ADDENDUM NO. 2

VILLAGE OF COVINGTON Wastewater Treatment Plant Improvements Phase II Blower Replacement February 19, 2019

Re: Village of Covington
Wastewater Treatment Plant Improvements Phase II – Blower Replacement

SLUDGE THICKENER BUILDING - PLAN
SCALE - 1/4" = 1'-0"

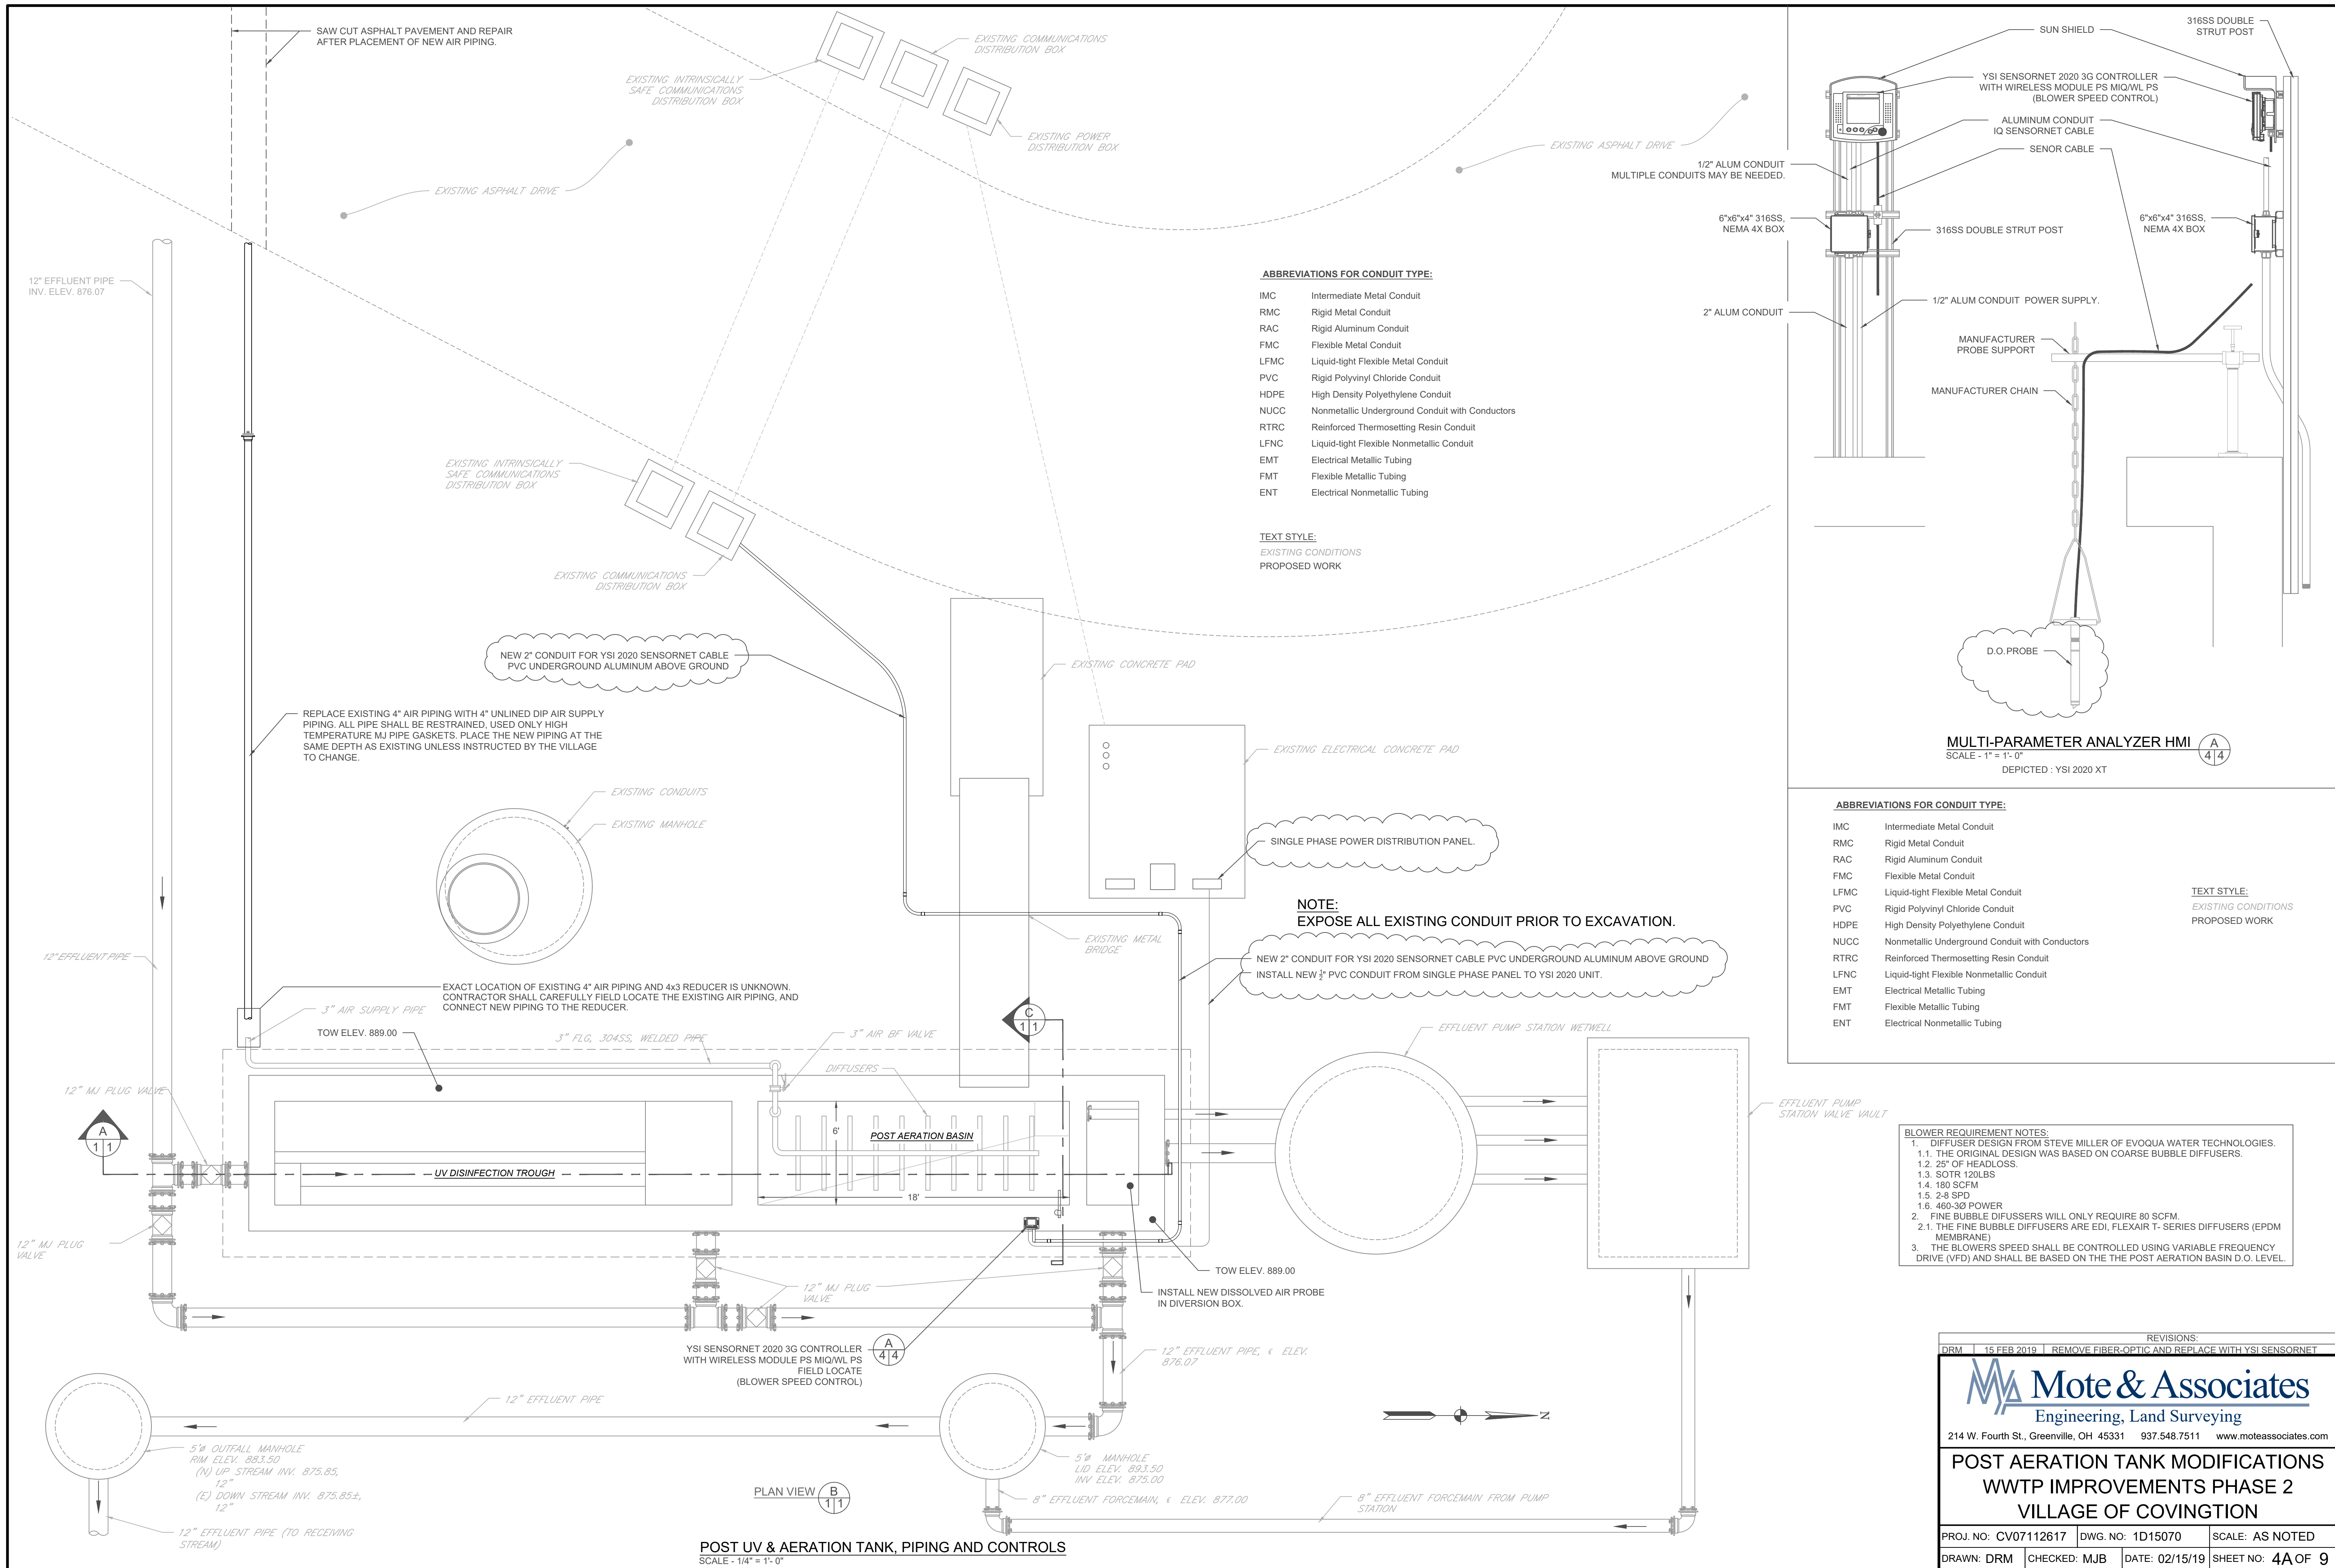
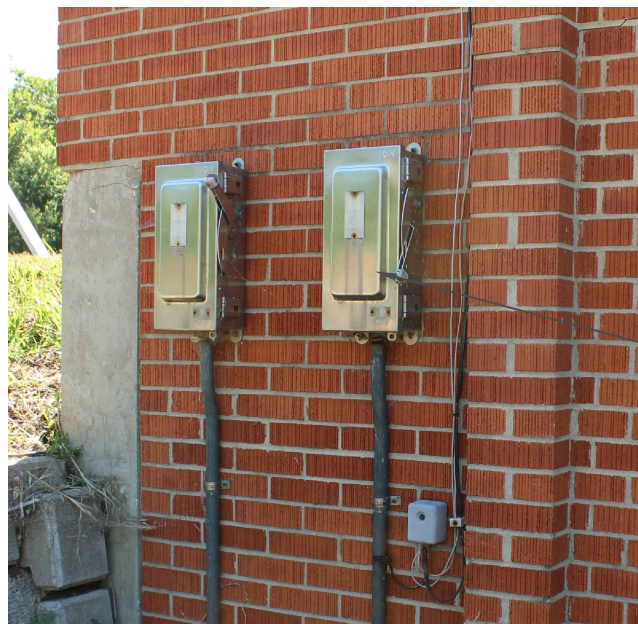
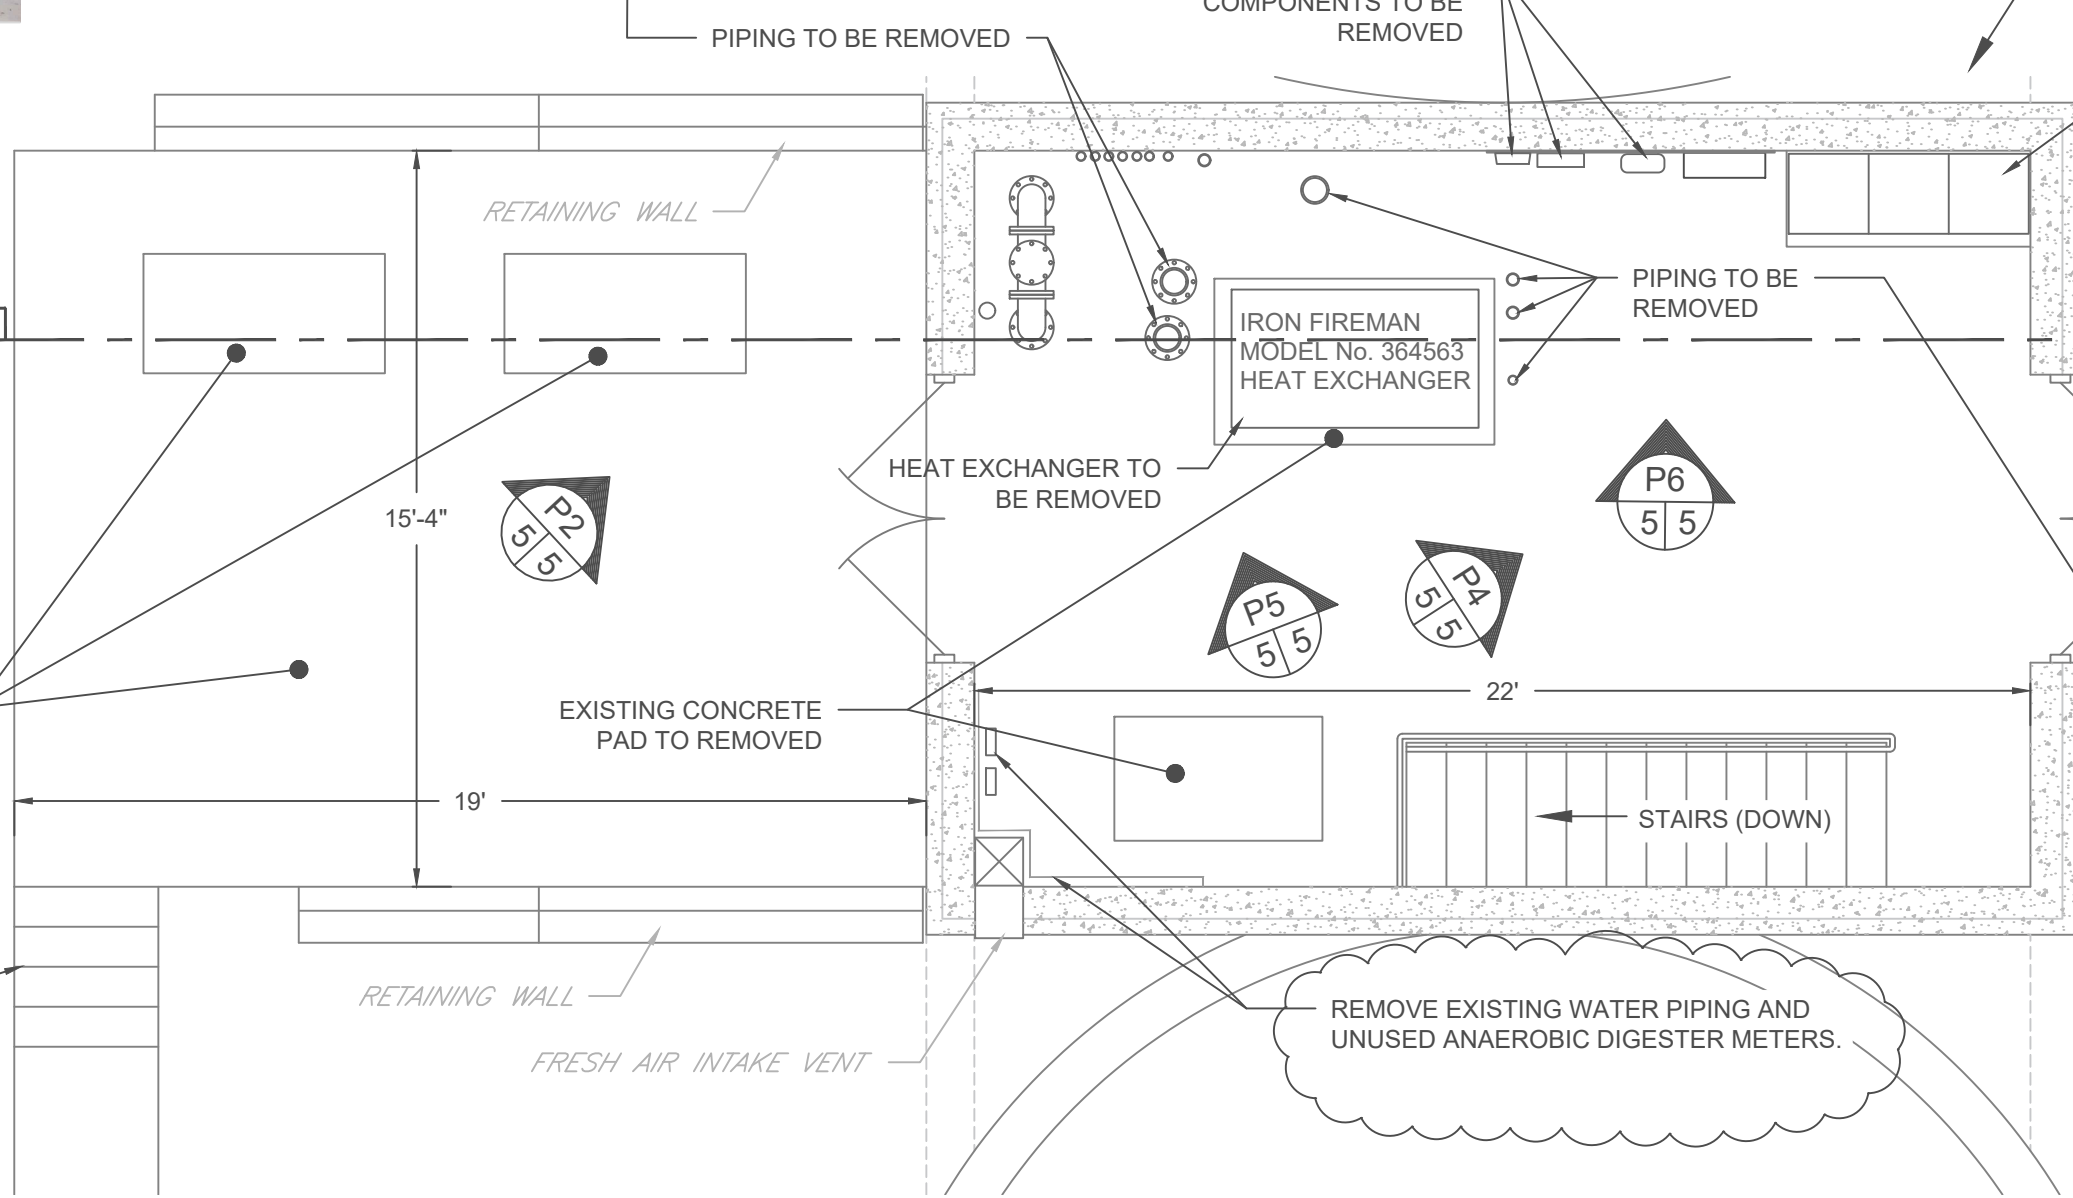
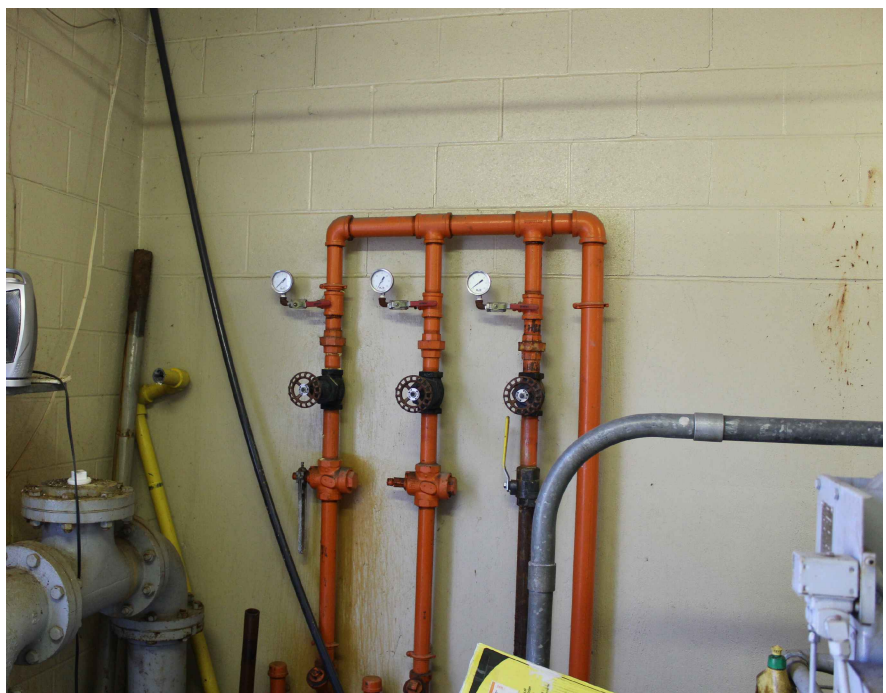
3. Sheet 2A has been updated indicated the amount of air piping to be replaced.
4. Sheets 3A, 4A, 6A, 8A and 9A indicate the changes from fiber-optic to SensorNet Cables.
5. Sheet 5A clarifies the water piping and obsolete equipment to be removed.

HEAT EXCHANGER TO BE REMOVED

EXISTING CONCRETE PAD TO BE REMOVED AND
BLOWERS TO BE REMOVED.
THE CONCRETE PAD TO BE REPLACED WITH NEW.

EXISTING CONCRETE STEPS TO REMOVED
AND REPLACED WITH NEW.
